LAND USE BOARD APPLICATION

Project:		PROPOSED RENOVATION & ADDITION 19 GRAVELLY POINT ROAD UNIT 19 HIGHLANDS LOT: 26.19 BLOCK: 100	
Owner:		MR. JOHN NASASI 19 GRAVELLY POINT ROAD HIGHLANDS NJ

Re: Completeness Review No. 1
Applicant: Nastasi
19 Gravelly Point Road
Block 100, Lot 26.19
Borough of Highlands, Monmouth County, New Jersey
Our File No.: HLPB24-04

Drawing Title: LIL JOHN		
Project No.	Date	Drawn by:
2401	1.18.24	CF
CATHERINE FRANCO, AIA NJ RA A111411 NJ PP 5416		Dwg. No. Z3 3 of 3

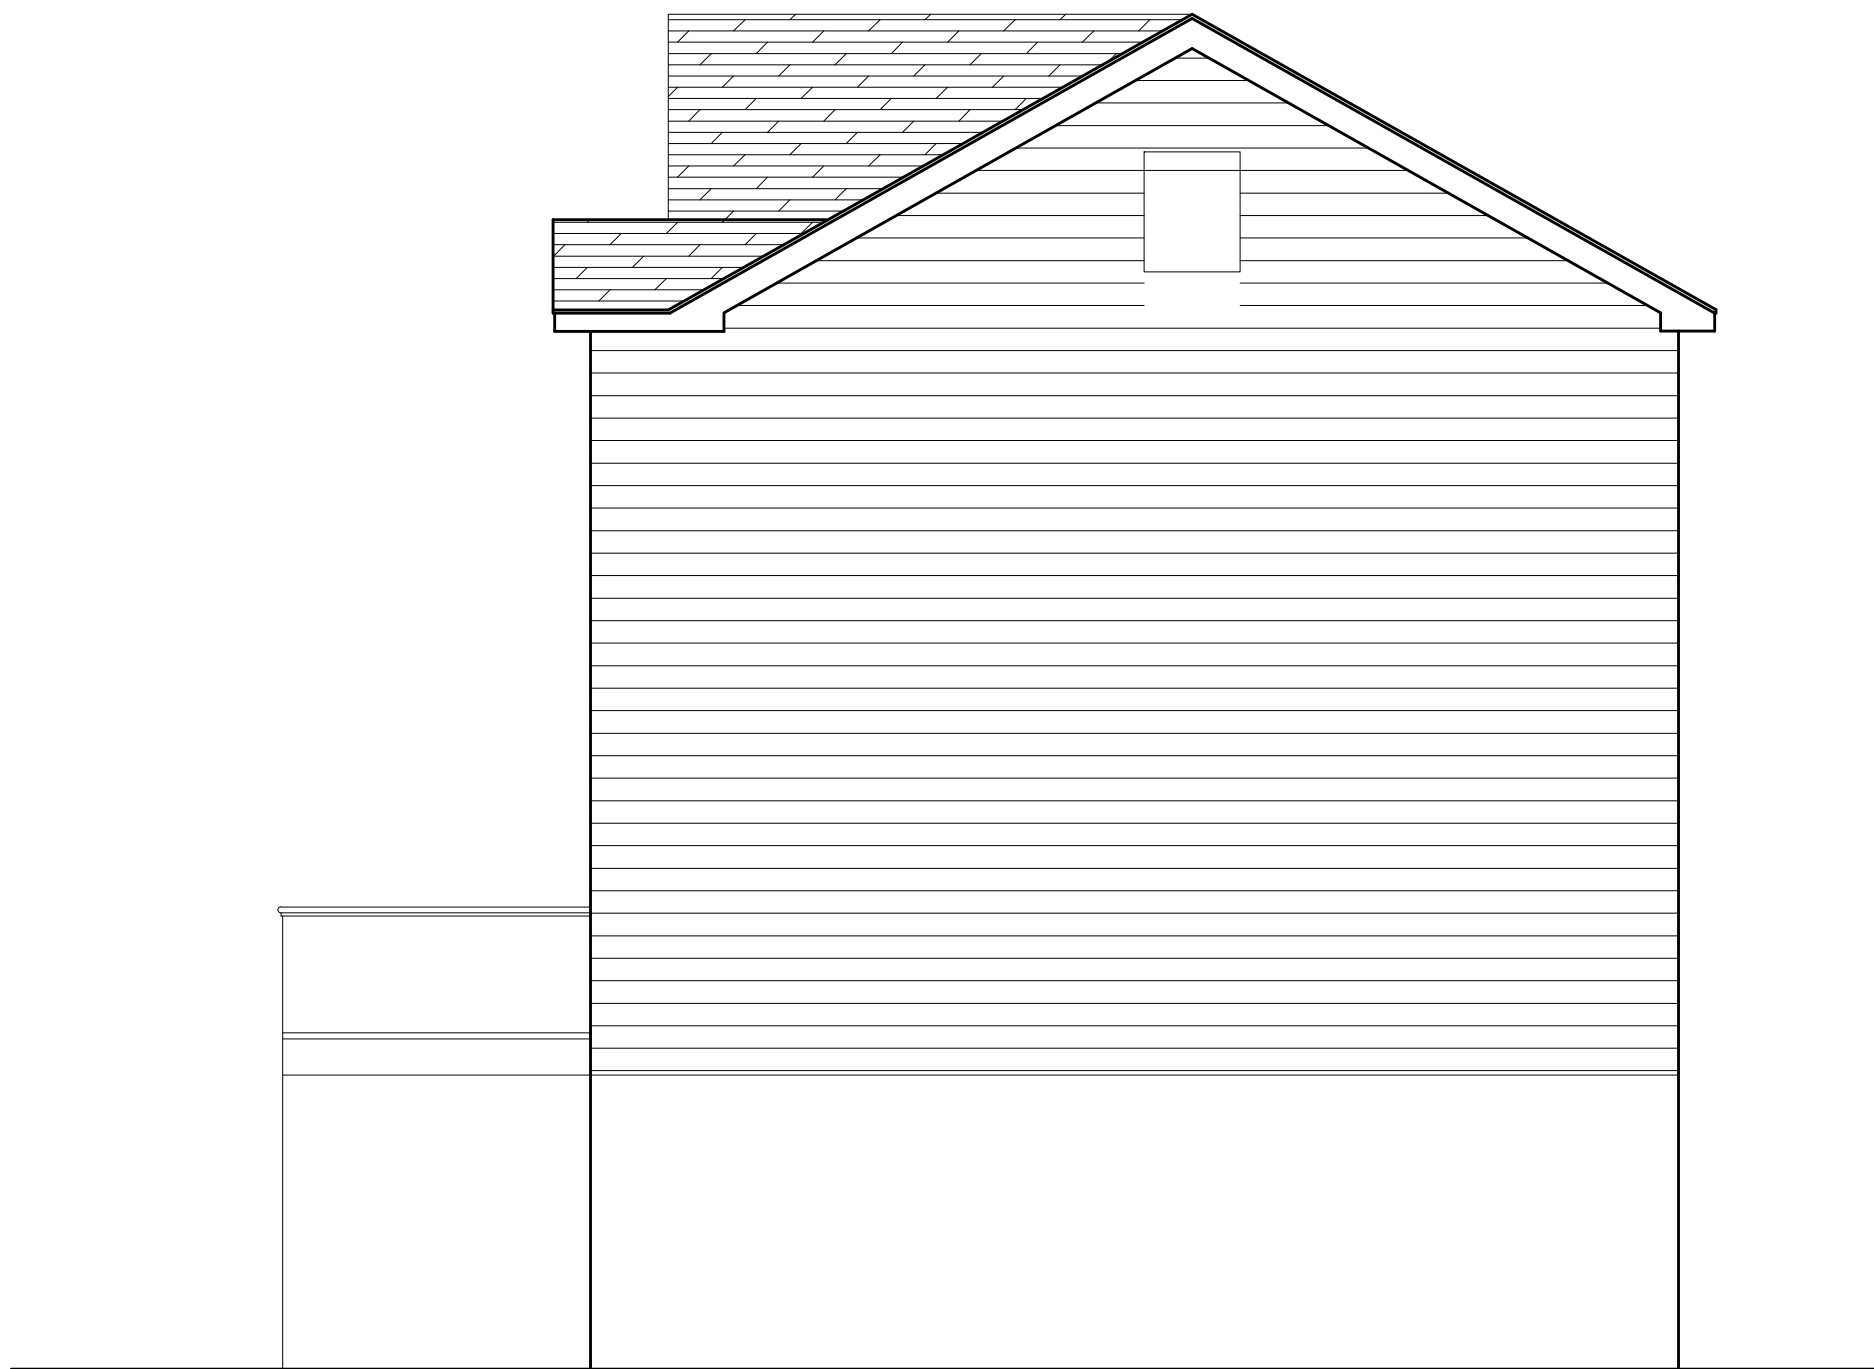
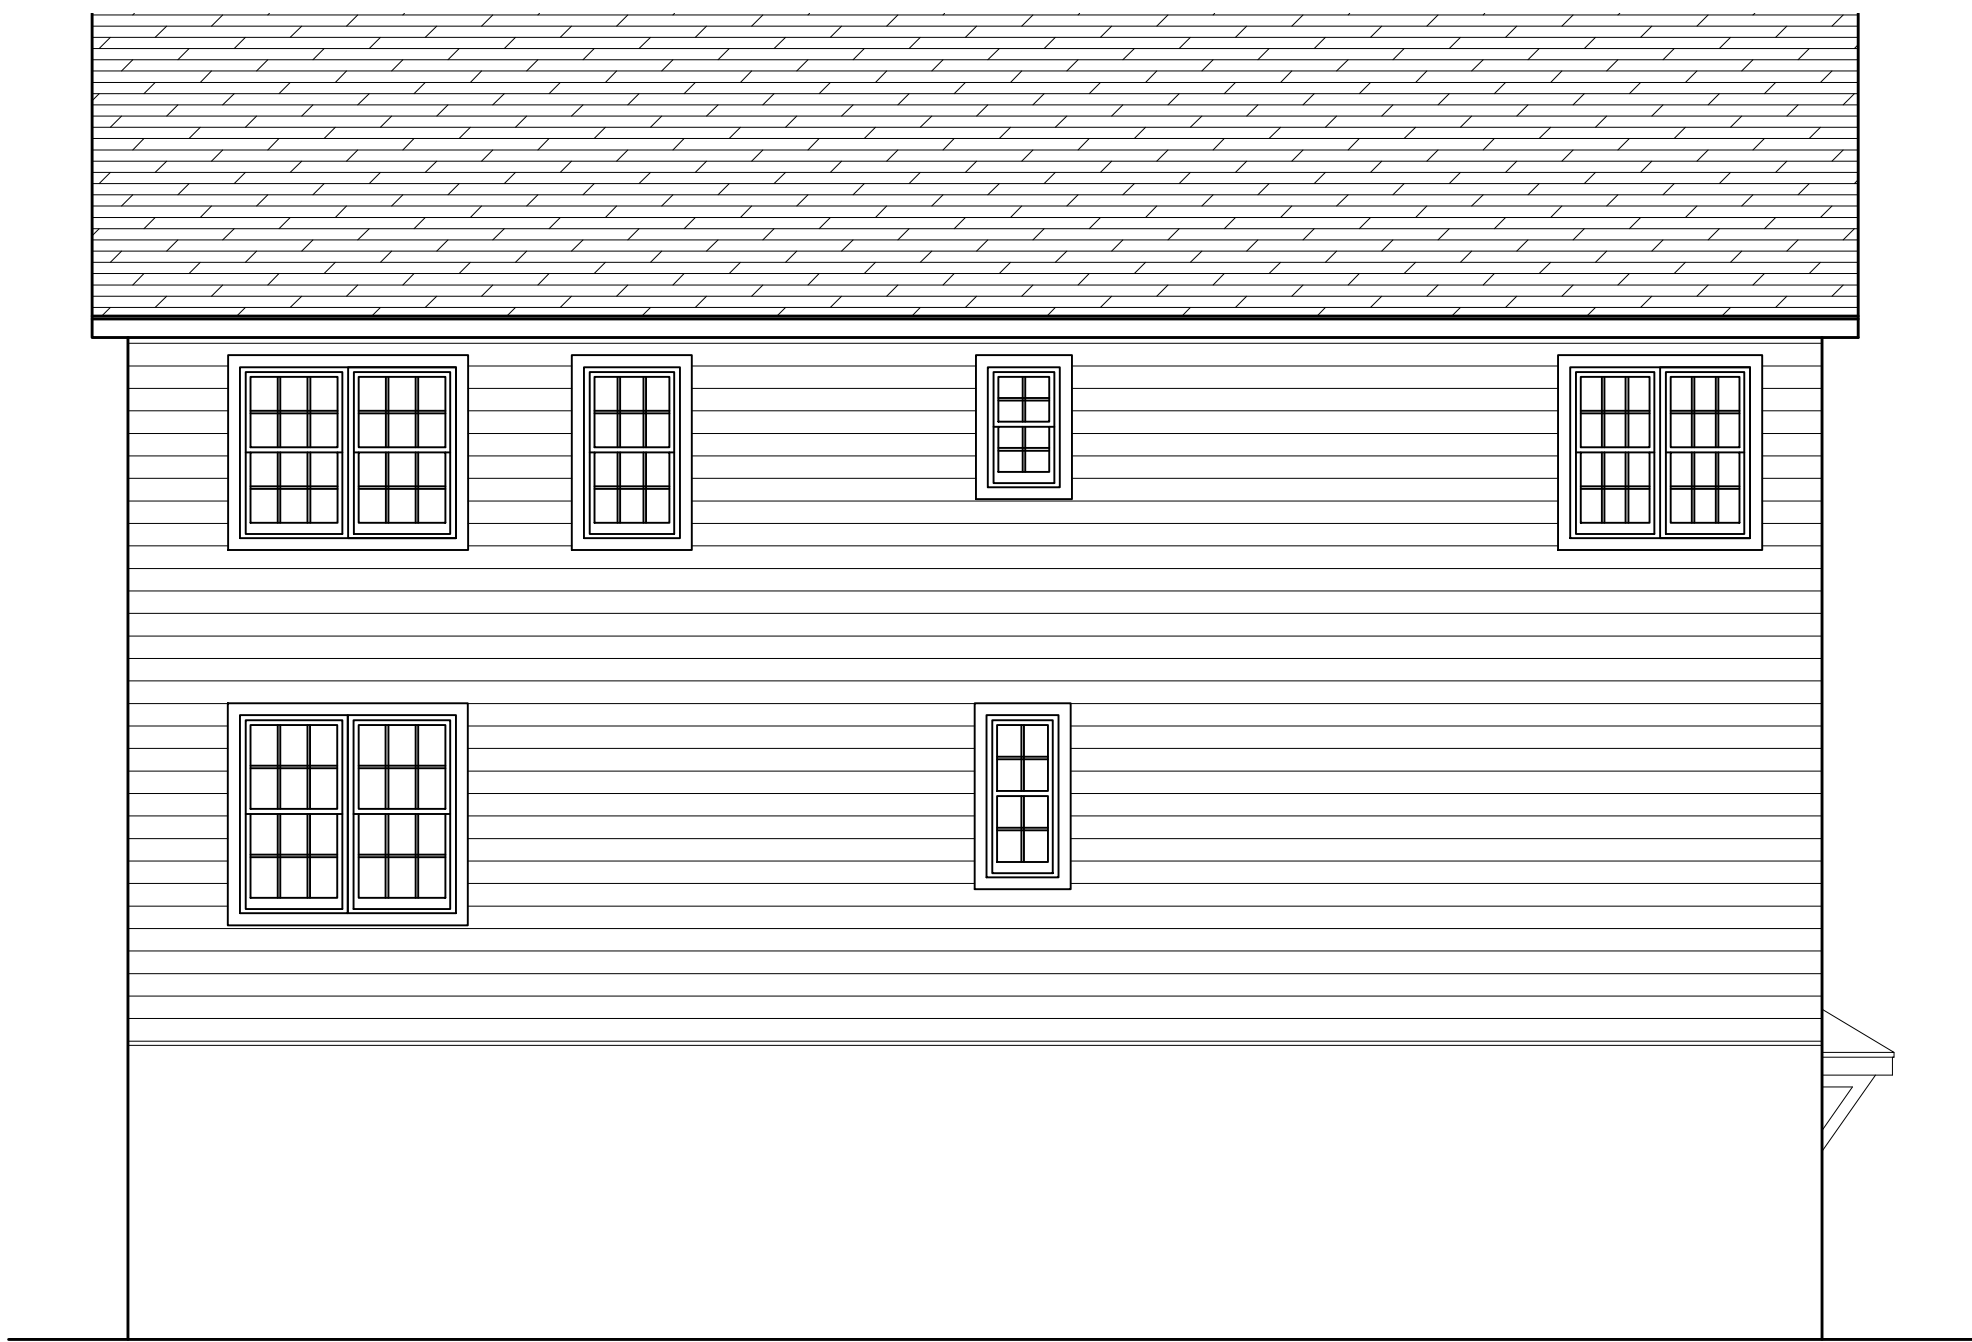
1. Please provide signed and dated architectural plans.
2. Please provide a zoning bulk and area requirements table on the plan noting zoning for bungalow parameters.
3. Please confirm the maximum existing and proposed building and lot coverages.
4. Please provide the nearest proposed front and side building offsets on the plan.
5. Please confirm the grade elevation on the architectural elevation sheet (3 of 3) as 6.56'.

The elevations along the front of the existing building range from 5.46 ft to 5.8 ft and 5.7 ft± along the northeasterly property line. The existing garage elevation is 6.06 ft.

The elevation of 6.56 ft ± appears to represent a building offset.

Please update architectural elevations.
